2nd PPP (22 July 2026- 26 August 2026)

**COMMENTS AND RESPONSE REPORT (CRR):
PROPOSED AMENDMENT OF MINING RIGHT NW 80
MR AND THE EXPANSION OF THE KWEZI MINING
OPERATIONS THROUGH THE INCLUSION OF THE
UG SHALLOWS BLOCKS (A&B)**

CLIENT NAME:	SIBANYE RUSTENBURG PLATINUM MINES (PTY LTD)
PROJECT NAME:	PROPOSED AMENDMENT OF MINING RIGHT NW 80 MR AND THE EXPANSION OF THE KWEZI MINING OPERATIONS THROUGH THE INCLUSION OF THE UG SHALLOWS BLOCKS (A&B)
REPORT DETAIL:	COMMENTS AND RESPONSE REPORT (CRR)
ALTA VAN DYK CORPORATE GROUP SUBSIDIARY	ALTA VAN DYK ENVIRONMENTAL CONSULTANTS (PTY) LTD

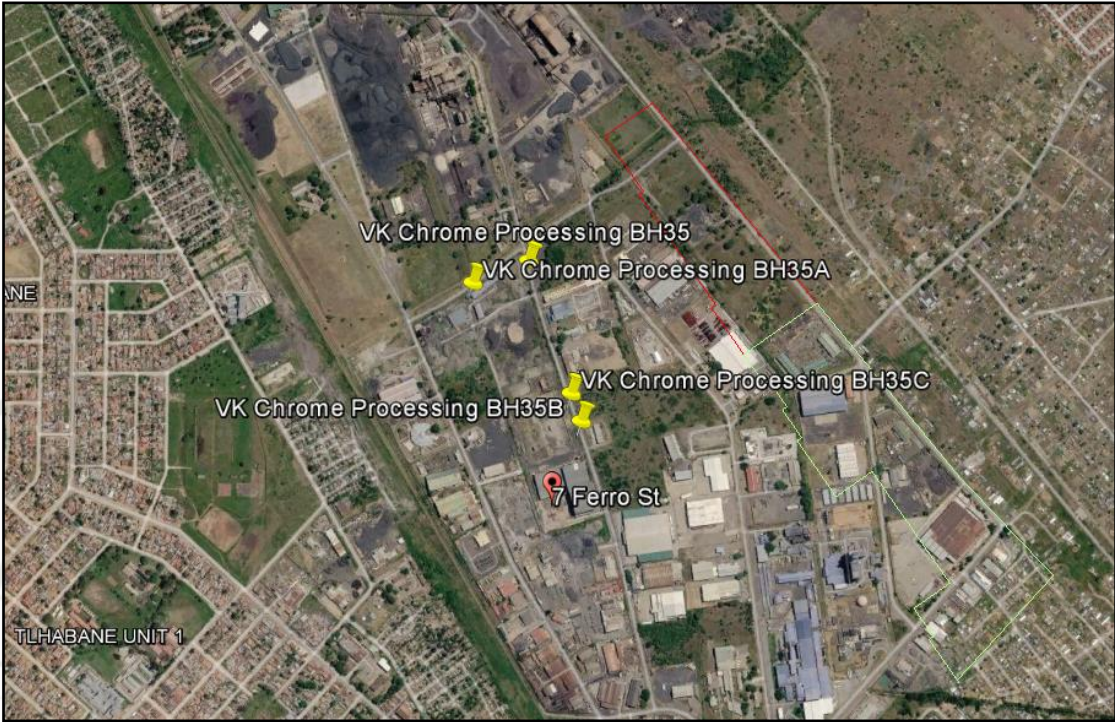
27.	16 July 2026 Email	Vuyisile Kona	1) I received the hydrology report for the Sibanye Kwezi shallow mining project in Rustenburg. However, I noticed that my boreholes, which were tested by your team, are not reflected in the final report. 2) Could you please assist me with this as soon as possible? 3) Name of the company: 4) VK Chrome Boreholes tested: 2 5) Ironveld Boreholes tested 2	The arial imagery below provides context of the property in question with regards to its locality from the Mining Block A&B

Nr.	Date and Source	Commentator and Organisation	Comment/Question	Responses
				 <u>To provide context:</u> An initial hydrocensus was undertaken in support of the project on the 3rd of October 2024 during which twenty-eight (28) properties were visited. Twenty-five (25) boreholes were identified during this census. During the initial public participation process several landowners indicated that their boreholes were not shown on the list. Many of the properties had been sub-divided and more than one borehole has been drilled by the business owners. A follow-up hydrocensus was therefore undertaken in December 2024 and January 2025. A further thirteen (13) boreholes were located. The figure below provides for the Hydrocensus Boreholes Summary:

Nr.	Date and Source	Commentator and Organisation	Comment/Question	Responses																																																												
				 In terms of the equery as raised above, AvDG (Pty) Ltd and Sibanye Rustenburg Platinum Mines Limited (SRPM) has noted that 4 boreholes are being enquired about. For “VK Chrome Processing” the following boreholes formed part of the Hydrocensus:
